**HISTORIC LANDMARK COMMISSION
DECEMBER 17, 2018
APPLICATION FOR A CERTIFICATE OF APPROPRIATENESS
LHD-2018-0028
703 Highland Avenue
Smoot/Terrace Park Historic District**

Construct a three-story house.

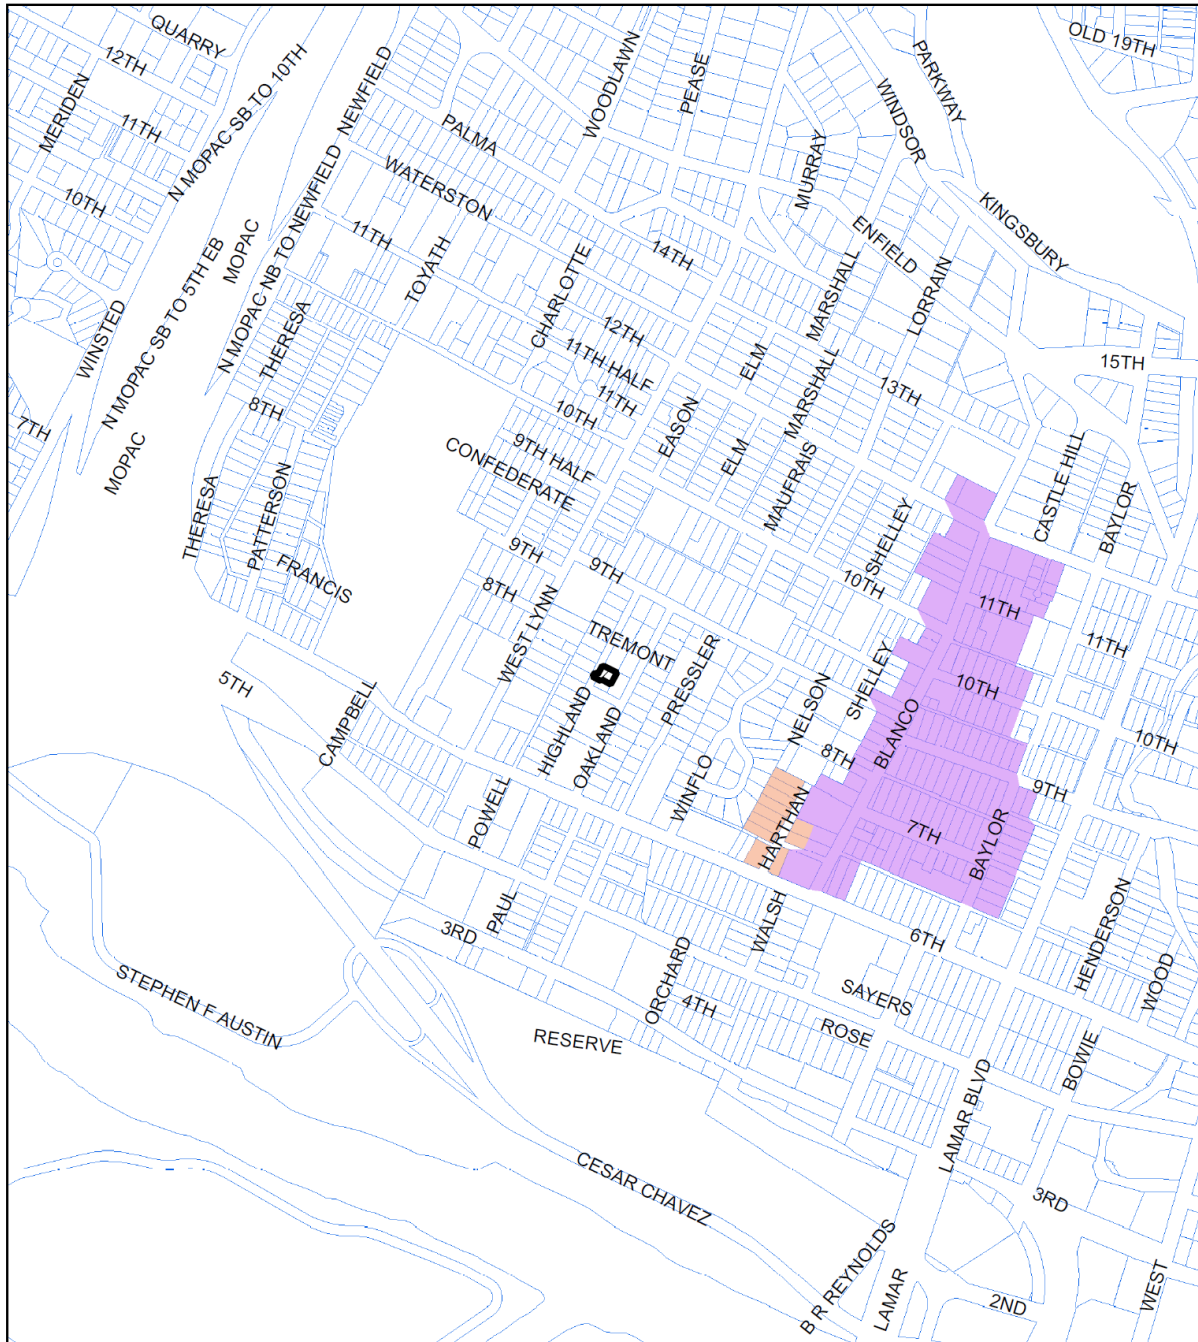
The committee felt that the design of the house was compatible with the neighborhood and kept the cadence of the street, particularly with the stepped-back central bay and its more modern style. The committee commended the design on its creative response to a unique site where a rear garage was not possible.

Committee members recommended approval of the plans contingent on adding articulation on the left bay, making windows on the primary façade consistent in size, adding detail and substance to the porte-cochere columns, and increasing the eave depth. The plans have been revised to respond to those recommendations.
